# Comments on February 14, 2014 draft SRRTTF QAPP and SAP

Friday, March 07, 2014

Prepared by Robert Steed,  
Surface Water Ecologist  
Coeur d' Alene Regional Office  
Idaho Department of Environmental Quality

#### QAPP A6 Project/Task Description

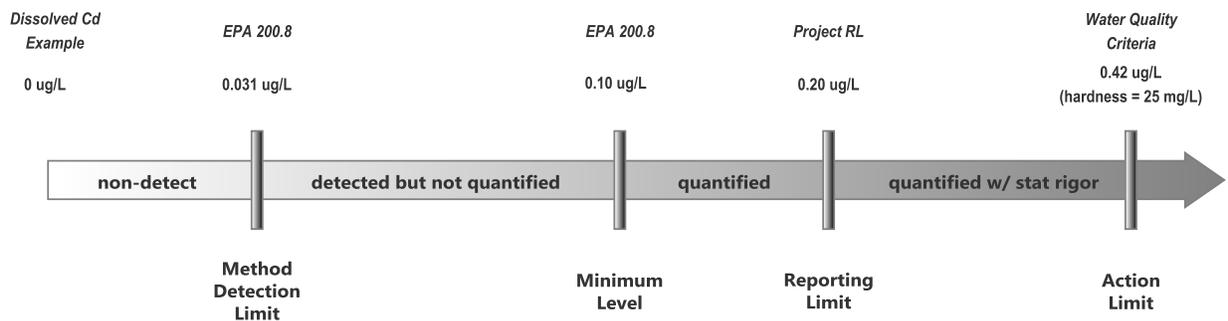
- It is debatable whether the current PCB monitoring database provides a good estimate of the amount of PCBs ... It is my opinion that previous monitoring is a poor estimate. Poor quality therefore poor estimate.
- “Robust” ≠ “more data are needed to support...”
- “The magnitude of true sources ...”, When using terms like true like this, and understanding that heterogeneity is the rule, aren’t we getting statistically in the realm of having n’s of 50 to 60 at a minimum?
- Synoptic Study: It’s agreed that the summer is the most stable time period, and the best for a study as proposed, but how do we know if the results are representative of the entire year, or other time periods. How do we vet the summer period?

- Seasonal Integrated Sampling: The flow regimes for the upper Spokane River are controlled both by meteorological events and how Avista operates dams. Probably should clearly identify the flow regimes that are being targeted. What is the discharge during Spring high flow, Summer low flow, and especially the Winter moderate flow?
- Why is Little Spokane missing from the synoptic survey?
- While there are advantages to compositing samples it increases the opportunity for contamination bias. Low levels in the PPQ range is a new area for me to consideration. It's hard for me to understand how this project will minimize sample contamination.
- What two week period is being proposed? Is the selected two week period representative?
- Schedule is incomplete
- The purpose of each analyte or physical property in table 4 should be discussed.
